Tivat to Jaz Beach Road, Montenegro
Results of Traffic and Pedestrian Counts completed 18th – 21st
November 2020

Date: 10th December 2020
Report requested by: EBRD
Report prepared by: John Aldridge
Reference: jma_00029_002_

Figure 2.2: Traffic and pedestrian count locations. New roundabout location shown.

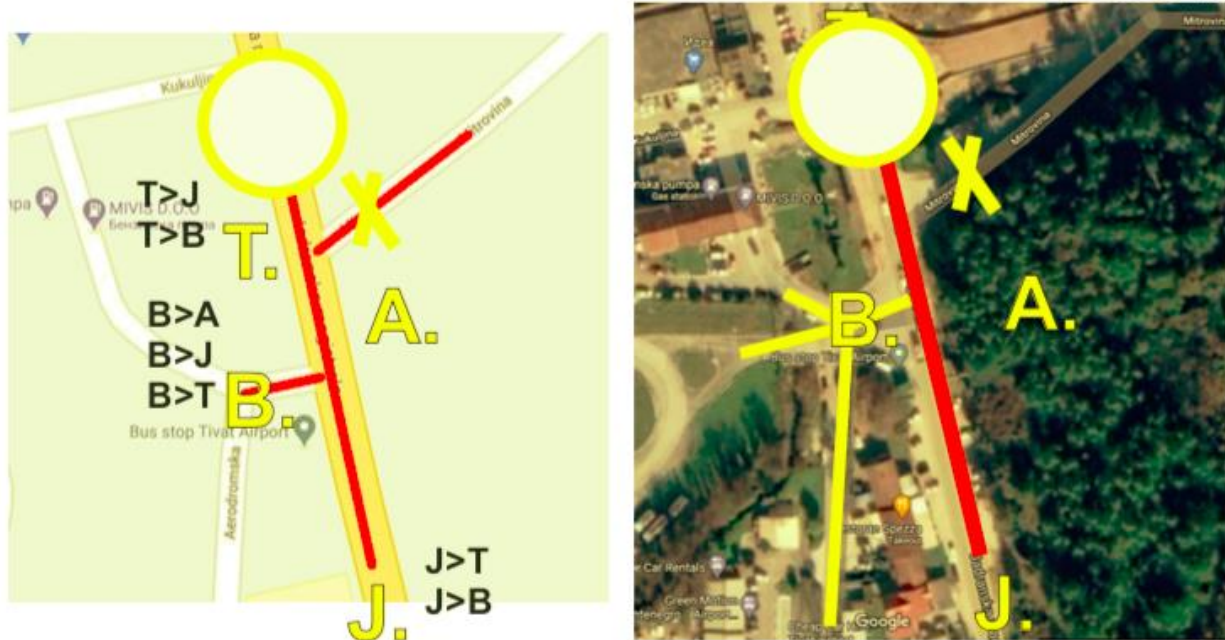
The initial road safety concern raised at this location was related to a concern of an anticipated high proportion of turning vehicles at the crossroad junction and also the risk to pedestrians to cross a multi lane road over an uncontrolled crossing. To address the road safety concern it was recommended that a roundabout or signalised junction was provided at the location which also included pedestrian facilities. The history of the raised road safety issues at this location within the road safety audit report and subsequent responses by the designer and road safety team are included in Figure 2.4.

Previous report Ref	Safety Problem	Recommendations	Ranking H/M/L	Cost in €	Accepted/Declined	Designers Response	Audit Response
2	<p>At KM 885+277 approx. the proposed entrance to the airport is identified. The entrance to the airport is identified as an uncontrolled crossroad junction and entry movements to the airport are one way only. Crossroad junctions typically have a poor crash record as there are numerous turning movements present which have potential for conflicts. In addition, it is assumed that the entrance to the airport is likely to attract a high number of turning movements and therefore not only is the likelihood of conflict further increased at this location, but there is also a risk that congestion may also result as turning movements may be difficult to make due to high summer traffic volumes. Merging arrangements of the two, one way entry lanes is also not clear and may also result in potential conflicts.</p> <p>It is further noted at this location that an uncontrolled pedestrian crossing is proposed. The crossing necessitates pedestrians to negotiate 5 lanes of traffic, and as there may be potentially fast moving through traffic at this location there is an increased likelihood of conflict for any pedestrian who attempts to cross.</p>	It is recommended that the junction type at this location is reviewed and ideally a traffic signalised junction or roundabout is introduced.	HIGH	Signalised junction EUR 50K. Roundabout EUR 80k.	It is not accepted.	<p>Traffic lights at intersections were not the topic of the projected task, therefore, it is not even considered at the level of the design solution.</p> <p>If the Investor deems it necessary to do so, this should be the subject of a separate project.</p>	<p>The proposed junction layout remains a road safety concern as there are multiple uncontrolled turning points. There is no detail of traffic flows and turning movement numbers but analysing these may provide some justification for the most appropriate junction type. The proposed</p>

<p>uncontrolled pedestrian crossing over multiple lanes remains a high risk to pedestrians.</p>
--	--	--	--	--	--	---

The introduction of the recent new roundabout close to the survey site will need to be considered as part of the further works which are proposed to be completed as part of the upgrade of the Tivat to Jaz Beach Road. Access arrangements to and from the airport may be changed to account for the new roundabout.

Based on the conducted traffic surveys there is a demand for left turning vehicles into and out of the airport, there is also a right turn demand too, at the junction. The recorded figures from the traffic survey are expected to be lower than normally expected as the current Covid-19 pandemic is assumed to result in decreased aircraft travel and therefore less turning movements into and out of the airport. Taking into account the recorded turning movements during a pandemic and within the low season (traffic flows are typically twice as high in the summer) the recommendation remains that a traffic signal or roundabout is introduced at this location (subject to review and clarification of access arrangements permitted at the new, nearby recently introduced roundabout). It is further recommended that a controlled pedestrian crossing facility is also introduced at this location. Pedestrian activity across the Tivat to Jaz Beach Road were recorded throughout the survey period, and again this activity is likely to be higher during the summer and when the current pandemic crisis has ended. Note, again the location of any pedestrian crossing needs to be reviewed in liaison with the newly introduced roundabout close to the survey site as this may result in a change in pedestrian desire lines due to changes in future entry points to the airport.

Figure 4.3: Extract from the Road Safety Audit report

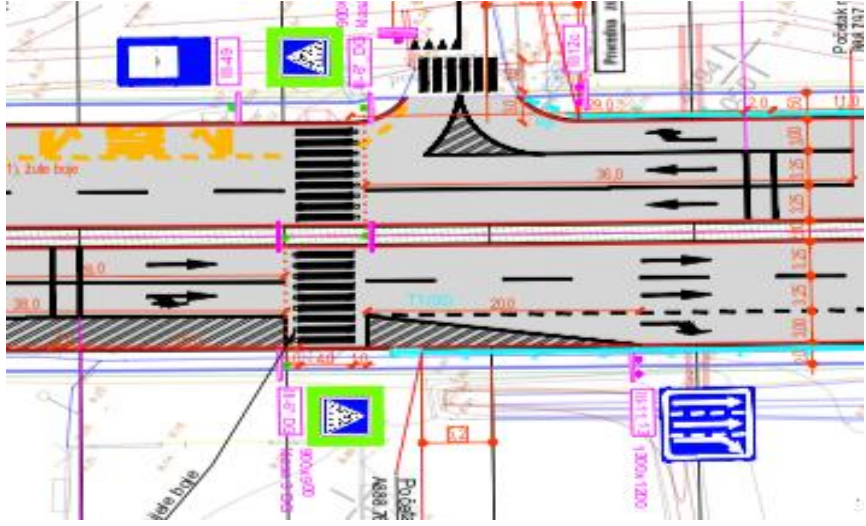
<p>10</p>	<p>An uncontrolled pedestrian crossing is proposed at km 888+755. A pedestrian crossing over a multiple lane highway where speeds are likely to be high (although posted as low speed), and where there is an additional danger of a vehicle stopping in one lane, but not the other lane, puts pedestrians at an increased risk of being struck by passing vehicles.</p> <p>It is further noted on the west side of the carriageway that the hatched road markings may provide an unclear message to road users. Pedestrians may stand in the area as they consider it a sheltered area to wait to cross, whilst the area may also be driven over by motorists who drive over the hatched area to make the right turn lane ahead. This ambiguity may lead to positive increased likelihood of conflict between pedestrians and motorists.</p> 	<p>It is recommended that grade separated pedestrian crossings (bridges) are introduced on multiple lane roads where vehicle speeds are expected to be high. Alternatively, a push button signalised pedestrian crossing is introduced. Rumble strips are not likely to obtain the required speed reduction.</p>	<p>HIGH</p>	<p>Bridge EUR 100k. Signalised push button pedestrian crossing EUR 30k.</p>	<p>It is not accepted.</p>	<p>The traffic lights at the intersection, as well as the foot-bridge project, were not the topic of the projected task, therefore, it is not even considered at the level of the design solution. If the Investor deems it necessary to do so, this should be the subject of a separate project.</p>	<p>The road safety concern remains. The higher cost for an appropriate solution may be justified in terms of road safety. The justification for the pedestrian crossing type is usually determined by the number of pedestrian movements and vehicle speeds and volumes. This information is not available to the RSA Team.</p>

Based on the road safety concerns raised within the Road Safety Audit report a traffic signal controlled pedestrian crossing was recommended at this location. The conducted pedestrian count survey has recorded a low number of pedestrian activity at this location. These figures may be lower than usual due to Covid-19 and accounting for the low season, as flows may be higher in the summer.

Although the pedestrian flows recorded are low, the upgraded road still results in the introduction of multiple lanes of traffic. In addition, vehicle flows are relatively high (recorded AADT at this site location was 15,498 on day 3 of the survey) and double during the summer months. This makes it a challenging and dangerous environment for pedestrians to cross. Therefore the introduction of a push button traffic signal operated crossing is still recommended at this location.

Figure 5.2: Proposed uncontrolled pedestrian crossing over multiple traffic lanes at Site 4.

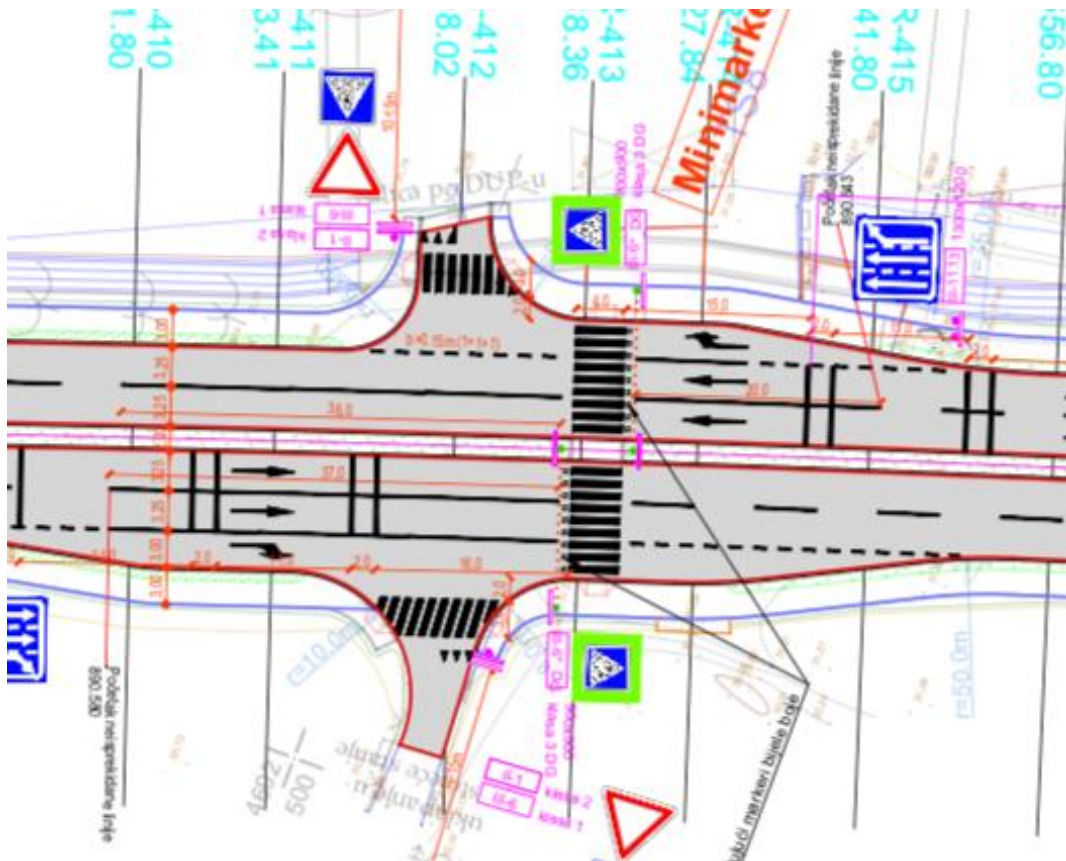
The road safety audit report completed for the Tivat to Jaz Beach Road raised concerns about the proposed uncontrolled pedestrian crossing at this site location across multiple lanes of traffic as shown in the drawing extract in figure 5.2. The survey has therefore counted pedestrian movements at the location for 4 days from 0600 – 1800hrs on each day to ascertain pedestrian demand and to help determine what sort of crossing is appropriate for pedestrians at this location.

<p>13</p>	<p>An uncontrolled pedestrian crossing is proposed at km 890+386. & km 890+618. Pedestrian crossings over a multiple lane highway where speeds are likely to be high (although posted as low speed), and where there is an additional danger of a vehicle stopping in one lane, but not the other lane, put pedestrians at an increased risk of being struck by passing vehicles.</p> 	<p>It is recommended that grade separated pedestrian crossings (bridges) are introduced on multiple lane roads where vehicle speeds are expected to be high and breaks in the traffic are limited, especially during peak summer flows. Alternatively a push button pedestrian crossing is introduced.</p>	<p>HIGH</p>	<p>Bridge EUR 100k. Signalised pedestrian push button crossing EUR 30k.</p>	<p>It is not accepted.</p>	<p>The traffic lights at the intersection, as well as the foot-bridge project, were not the topic of the projected task, therefore, it is not even considered at the level of the design solution. If the Investor deems it necessary to do so, this should be the subject of a separate project.</p>	<p>The road safety concern remains. The higher cost for an appropriate solution may be justified in terms of road safety. The justification for the pedestrian crossing type is usually determined by the number of pedestrian movements and vehicle speeds and volumes. This information is not available.</p>

Based on the road safety concerns raised within the Road Safety Audit report a traffic signal controlled pedestrian crossing (or pedestrian bridge) was recommended at this location. The conducted pedestrian count survey has recorded a total of 246 pedestrian crossing movements at this location over the 4 days with 81 pedestrians recorded on the Saturday. These figures may be lower than usual due to Covid-19 and accounting for the low season, as flows may be higher in the summer.

As there appears to be consistent pedestrian demand at this location a facility for safe pedestrian crossing movements should be provided. The proposed works on the project road result in the widening of the road to multiple lanes in each direction with a median. This creates a more challenging crossing environment for pedestrians as well as potentially higher speeds. Therefore the introduction of a push button traffic signal operated crossing is still recommended at this location. A pedestrian bridge is considered inappropriate based upon the recorded pedestrian numbers.

Figure 6.2: Proposed uncontrolled pedestrian crossing over multiple traffic lanes and crossroad junction at Site 5.

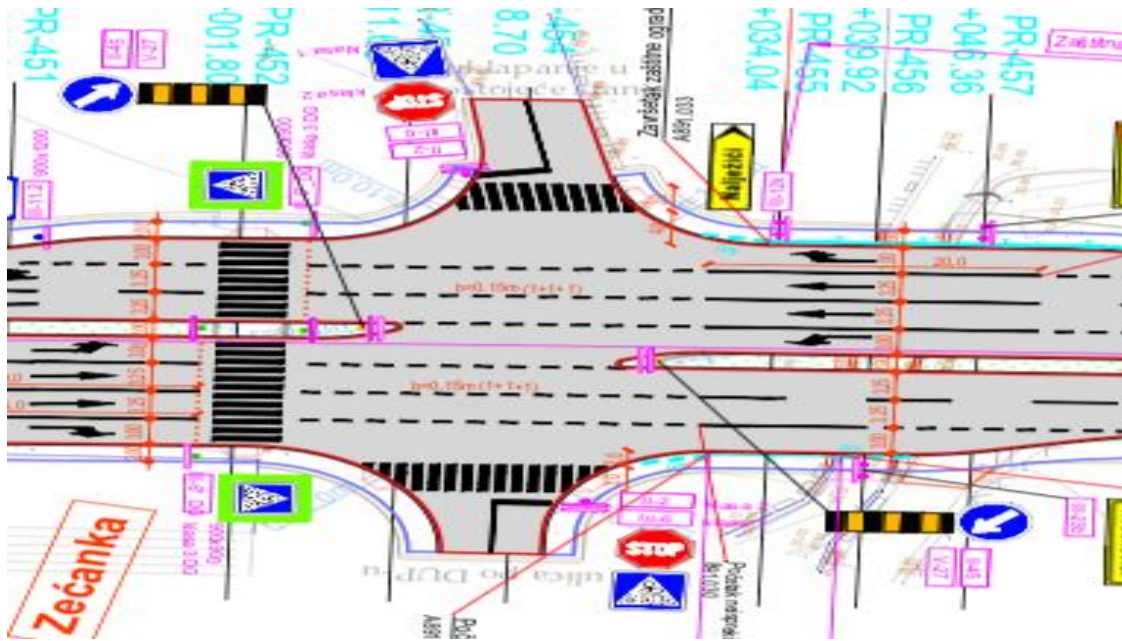
The road safety audit report completed for the Tivat to Jaz Beach Road raised concerns about the proposed crossroad at this location as these types of junctions have a poor crash record. It was therefore recommended that a roundabout or traffic signal junction is introduced in place of the proposed gap in the median. There was also a concern raised regarding the uncontrolled pedestrian crossing across multiple lanes of traffic as shown in the drawing extract in figure 6.2. The survey has therefore counted pedestrian

15	<p>A crossroad junction with an at-grade uncontrolled pedestrian crossing is proposed at km.891+018. Crossroad junctions have a poor crash history as multiple turning points are present and therefore there are many potential conflict locations. For pedestrians at this location their safety is compromised as there are potentially 7 lanes of traffic to cross therefore exposing pedestrians at a high risk of being struck by a passing vehicle.</p>	<p>It is recommended that the crossroad junction is replaced with a roundabout. This will also provide a safer environment for crossing pedestrians.</p>	HIGH	<p>Roundabout estimated at EUR 50k>.</p>	<p>Designing a roundabout at this intersection would lead to the demolition of existing commercial buildings on both the left and right sides of the boulevard.</p>	<p>In the absence of a roundabout an alternative solution should be sought, i.e traffic signals. This is a potentially high risk location for pedestrians and turning vehicles if it remains as a multi-lane, uncontrolled junction.</p>

The previously completed Road Safety Audit report recommended that the proposed gap in the median was replaced with a roundabout. Based on the results from the survey this remains the recommended solution. However, as the design team has stated this would not be possible due to land appropriation, the introduction of a traffic signalised junction could be considered as an alternative arrangement together with facilities to provide a pedestrian phase to enable safe pedestrian crossing.

In the absence of a roundabout or a signalised crossing, the next alternative would be to close the gap in the median and to expect vehicles to U turn at the nearby roundabouts at km 889+500 approximately to the north, or km 891+950 to the south. As turning movements are relatively high at survey site 5, it is recommended that additional turning movements which will be displaced to the neighbouring roundabouts should be modelled to ensure that the displaced movements do not exceed the operational capacity of the roundabouts at these nearby locations. If the gap in the median is closed at Site 5, it is still recommended that a pedestrian crossing facility is provided at this location. A signalised pedestrian crossing activated by a push button would be appropriate.

Figure 7.2: Proposed uncontrolled pedestrian crossing over multiple traffic lanes

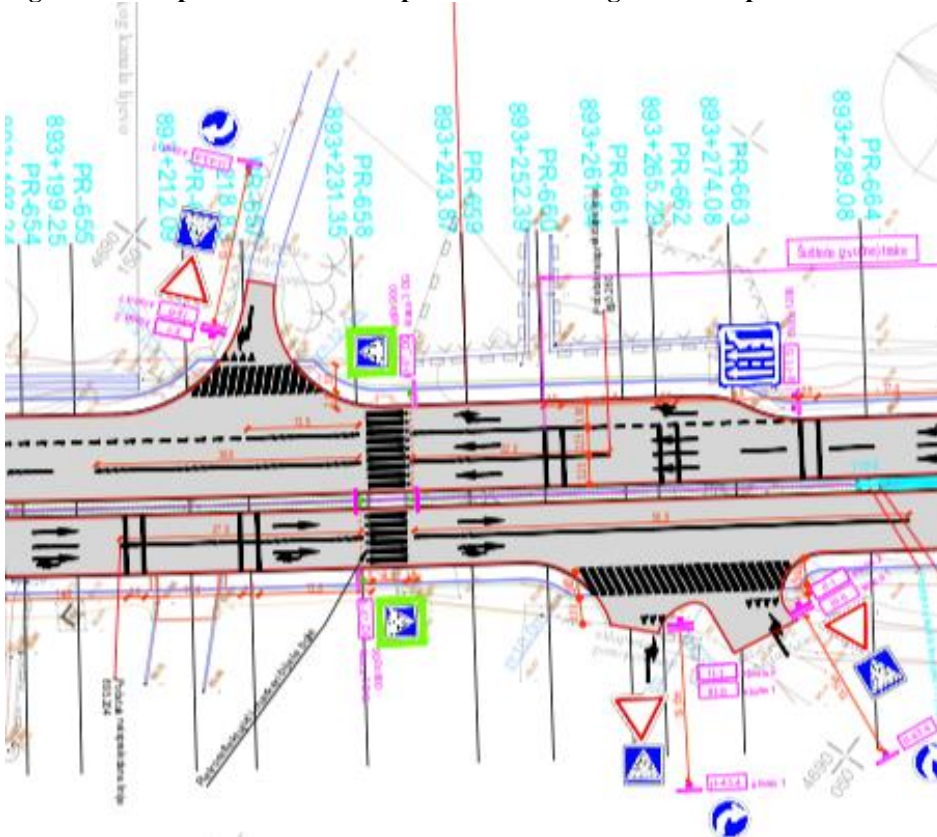
The road safety audit report completed for the Tivat to Jaz Beach Road raised concerns about the proposed uncontrolled pedestrian crossing at this site location across multiple lanes of traffic as shown in the drawing extract in figure 7.2. The survey has therefore counted pedestrian movements at the location

22	<p>At km 893+231 an at-grade pedestrian crossing is proposed. An at-grade uncontrolled pedestrian crossing across five lanes of traffic of traffic places pedestrians at risk. There is the potential danger that a vehicle in one lane may stop to allow a pedestrian to cross, and then another vehicle travelling in another lane may fail to stop thereby potentially striking the crossing pedestrian.</p>	<p>It is recommended that a pedestrian bridge is introduced. Alternatively a traffic signalised, push-button pedestrian crossing is introduced.</p>	<p>HIGH</p>	<p>Pedestrian bridge estimated at EUR 100k. Signalised pedestrian crossing EUR30k.</p>	<p>It is not accepted.</p>	<p>The traffic lights at the intersection, as well as the foot-bridge project, were not the topic of the projected task, therefore, it is not even considered at the level of the design solution. If the Investor deems it necessary to do so, this should be the subject of a separate project.</p>	<p>The road safety concern remains. The higher cost for an appropriate solution may be justified in terms of road safety. The justification for the pedestrian crossing type is usually determined by the number of pedestrian movements and vehicle speeds and volumes. This information is not available.</p>

As there appears to be a low pedestrian demand at this location a pedestrian bridge is not justified. However, it is still recommended that a facility for safe pedestrian crossing movements should be provided. The proposed works on the project road result in the widening of the road to multiple lanes in each direction with a median. This creates a more challenging crossing environment for pedestrians as well as potentially higher speeds. Therefore the introduction of a push button traffic signal operated crossing is still recommended at this location. If funds are low to provide such a facility and only limited numbers of signalised crossing could be provided, this would be considered a lower priority site.

Figure 8.3: Extract from the Road Safety Audit report

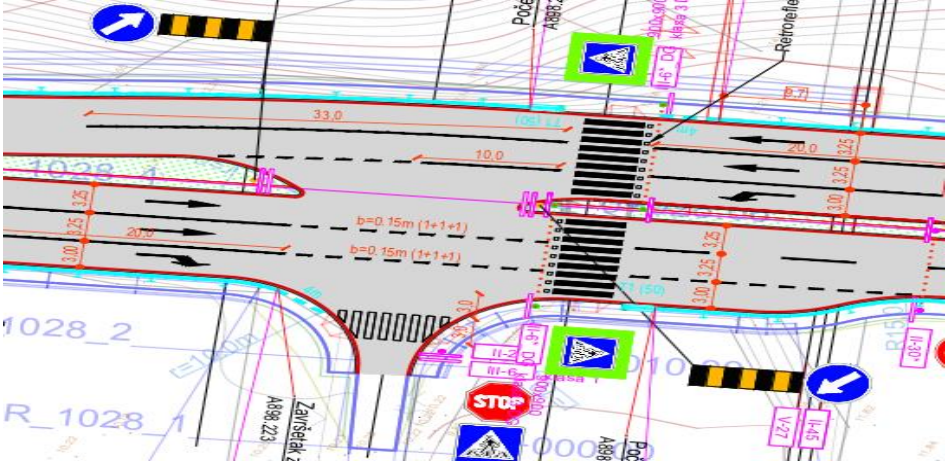
The road safety audit report completed for the Tivat to Jaz Beach Road raised concerns about the gap in the median which will permit left turn movements across the project road. In addition, a proposed uncontrolled pedestrian crossing at this site location across multiple lanes of traffic as shown in the drawing extract in figure 8.2 provides a challenging and unsafe environment for pedestrians to cross. The survey has therefore counted pedestrian movements at the location for 4 days from 0600 – 1800hrs on

<p>30</p>	<p>At km 898+231 there is a proposed break in the median to permit left turn movements, in addition there is a proposed at grade uncontrolled pedestrian crossing over 6 lanes of traffic. At grade crossings for traffic and pedestrians on multiple lane roads increase the risk of conflicts as generally through traffic is travelling at higher speeds due to the design nature of the road and the likelihood of turning vehicles and crossing pedestrians is less likely to be expected.</p>  <p>The drawing shows a road layout with a central median break. It includes lane widths (e.g., 3.00, 3.75, 1.25, 10.0, 20.0, 33.0), pedestrian crossing markings, and various traffic signs such as 'STOP', 'Yield', and 'One-way'. Labels include 'Početak A888', 'Retrometije', 'Završetak A888', and 'R_1028_1'.</p>	<p>It is recommended that the junction design is replaced with a roundabout, this also provides a slower speed for crossing pedestrians. Alternatively the median gap is closed and signalised pedestrian crossing or pedestrian bridge is introduced.</p>	<p>HIGH</p>	<p>Roundabout estimated at EUR 50k >. Pedestrian bridge EUR 100k and signalised pedestrian crossing EUR 30k.</p>	<p>It is not accepted.</p>	<p>The traffic lights at the intersection, as well as the foot-bridge project, were not the topic of the projected task, therefore, it is not even considered at the level of the design solution. If the Investor deems it necessary to do so, this should be the subject of a separate project. At this location, the planned documentation does not provide a roundabout, and at a distance of 400 m there is a projected roundabout.</p>

Figure 9.2: Proposed uncontrolled pedestrian crossing over multiple traffic lanes

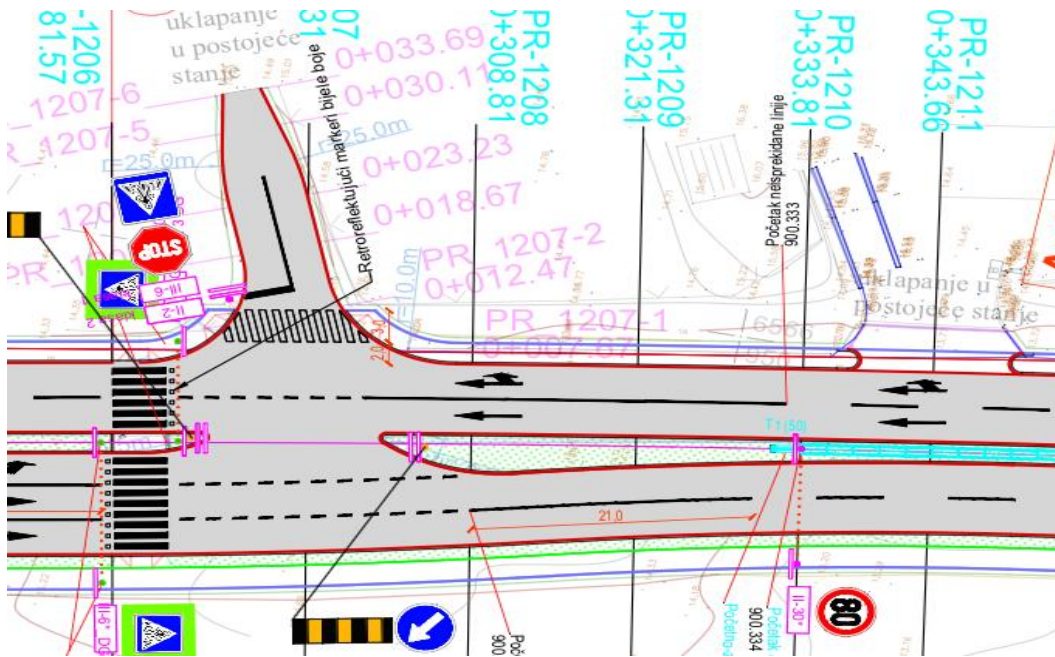
The road safety audit report completed for the Tivat to Jaz Beach Road raised concerns about the gap in the median which will permit left turn movements across the project road. In addition, a proposed uncontrolled pedestrian crossing at this site location across multiple lanes of traffic as shown in the drawing extract in figure 9.2 provides a challenging and unsafe environment for pedestrians to cross. The survey has therefore counted pedestrian movements at the location for 4 days from 0600 – 1800hrs on

35	<p>At km. 900+296 a minor junction is proposed. Also at this location there is a break in the median to enable left in and left out movements. The presence of an at-grade junction on a multi-lane road has the risk of an increased likelihood of high speed turning conflicts as multi lane roads tend to encourage higher vehicle speeds and the presence of at-grade turns is not usually expected. There are also other road safety concerns at this location as follows:</p> <ul style="list-style-type: none"> i) There is a proposed at-grade uncontrolled pedestrian crossing. The crossing is over 5 lanes of traffic and there is a risk of high speeds. Both of these factors increase the risk to crossing pedestrians. ii) 40m south of the proposed minor junction there is an access to a commercial premises, 'Auto Perionica'. There is a danger that vehicles which exit this commercial premises and then wish to proceed southbound may attempt to turn left at the nearby break in the median. This will necessitate vehicles moving across to the left side of the road over a short time at low speed therefore resulting with possible conflicts with traffic on the main road. It is further noted that the proposed access from the commercial premises provides a challenging radius which will result in slow entry and exit speeds to the project road to the detriment of road safety. 	<p>It is recommended that the gap in the median is closed, and instead vehicles use the nearby roundabouts for turning movements. It is further recommended that at-grade pedestrian crossing is replaced with a pedestrian bridge or a push button signalised pedestrian crossing. This may be upgraded to a signalised junction if turning movements justify the cost. The minor junction serving Auto Perionica should be closed and instead access made through the minor at km.900+296.</p>	HIGH	<p>Costs vary on options taken forward. Signalised junction estimated at EUR 80k. Closure of median, combination of access roads and acceleration and deceleration lanes estimated at EUR 10k. Pedestrian bridge EUR 100k. Signalised pedestrian crossing EUR 30k.</p>	<p>It is not accepted.</p>	<p>The traffic lights at the intersection, as well as the foot-bridge project, were not the topic of the projected task, therefore, it is not even considered at the level of the design solution. If the Investor deems it necessary to do so, this should be the subject of a separate project. The traffic solution will be supplemented by prohibiting left turns from the approach road.</p>	<p>The road safety concern remains. The higher cost for an appropriate solution may be justified in terms of road safety. The justification for the pedestrian crossing type is usually determined by the number of pedestrian movements and vehicle speeds and volumes. This information is not available.</p>
